# ST. TAMMANY PARISH PLANNING COMMISSION MEETING 6:00PM – TUESDAY, JULY 9, 2019 ST. TAMMANY PARISH GOVERNMENT COMPLEX PARISH COUNCIL CHAMBERS 21490 KOOP DRIVE, MANDEVILLE, LOUISIANA

# MINOR SUBDIVISION STAFF ANALYSIS REPORT (As of July 1<sup>st</sup>, 2019)

# PRELIMINARY SUBDIVISION STAFF ANALYSIS REPORT (As of July 2, 2019)

# FINAL SUBDIVISION STAFF ANALYSIS REPORT (As July 2, 2019)

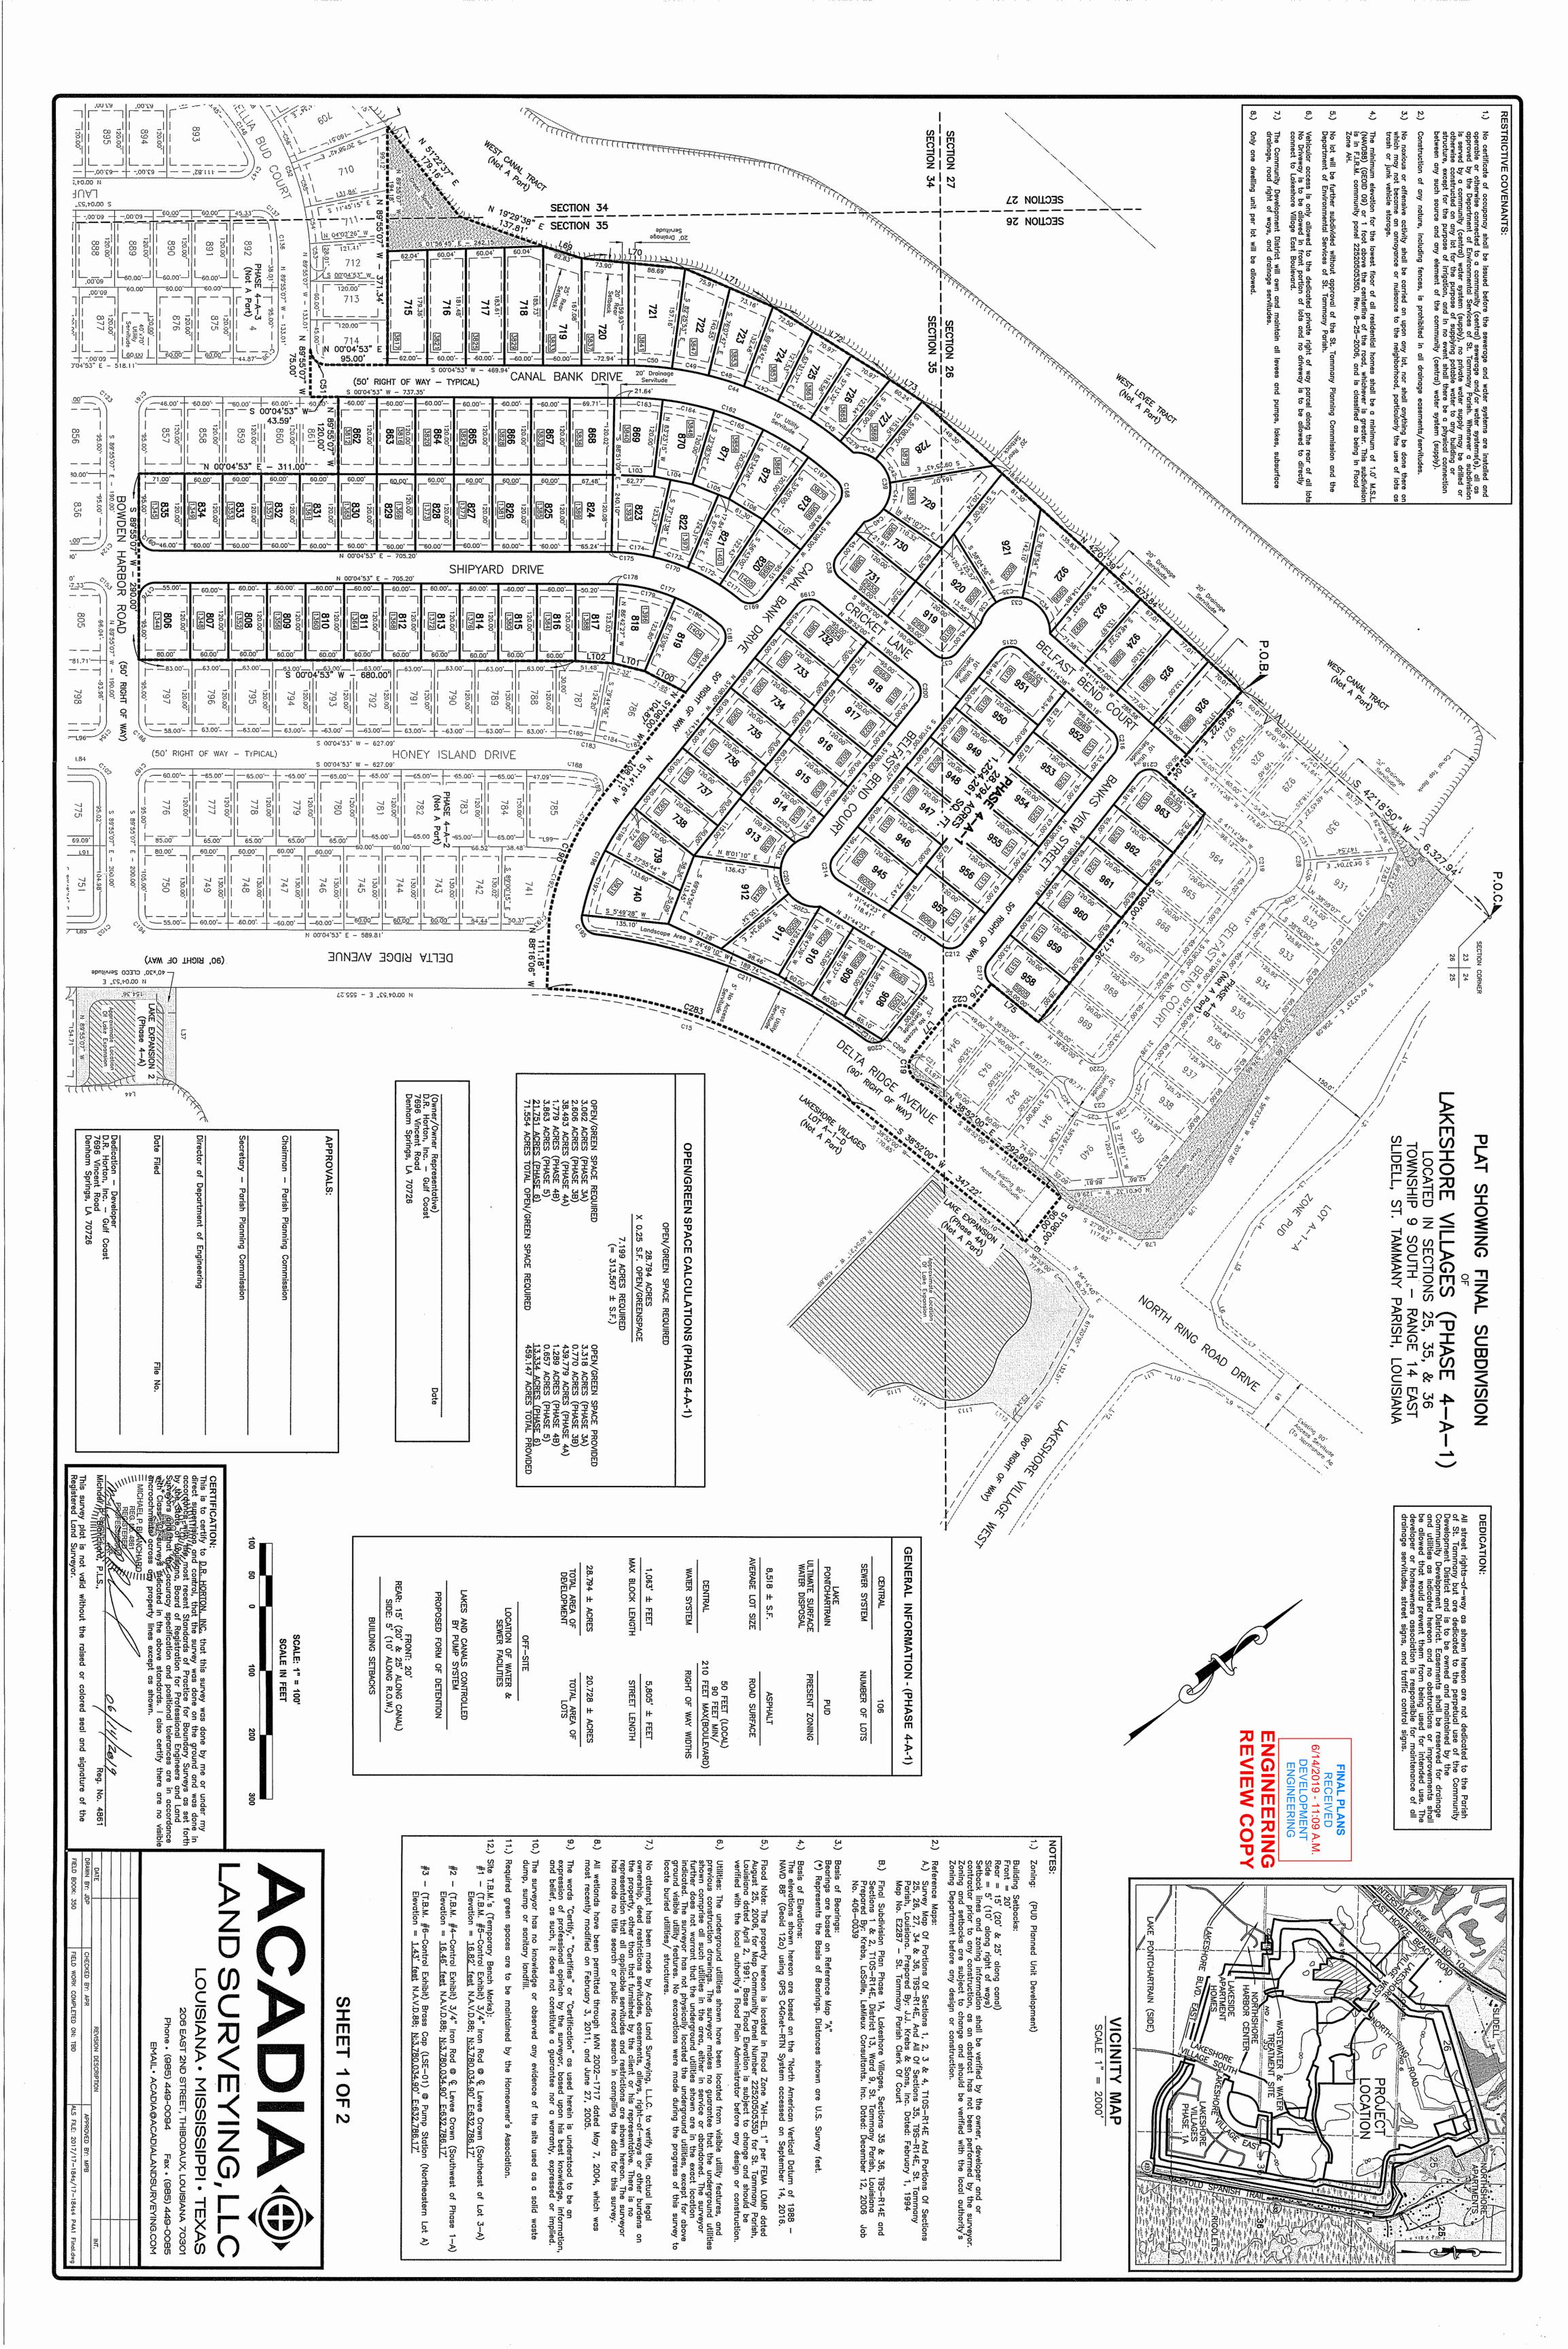
1. Provide asphalt core test results for all roadways in this phase.

- 2. Add a signature line for the Clerk of Court to both pages of the Final Plat.
- 3. Restrictive covenants need to be updated to reflect Ordinance Section 125-214.

- 4. Provide as-built information for the drainage pipe leaving drainage manhole #653.
- 5. Drainage structure 645 to structure 647 elevations do not provide positive flow. Verify invert elevations are correct for these structures.
- 6. Drainage structure 393 to structure 395 elevations do not provide positive flow. Verify invert elevations are correct for these structures.
- 7. Drainage structure 391 to structure 393 elevations do not provide positive flow. Verify invert elevations are correct for these structures.

- 8. Show sewer connections for lots #909 & #910.
- 9. Show water and sewer connections for lots #868 through #872.
- 10. Provide a letter of acceptance and responsibility for the perpetual maintenance and operation of the water and sewer system from the utility provider.
- 11. Provide a water and sewer system capacity letter verifying that the existing system has capacity to service this phase of Lakeshore Villages.

12. Sheet C-3.0 needs to be updated to show the yellow striping along Delta Ridge Avenue per the previously approved preliminary striping plans.
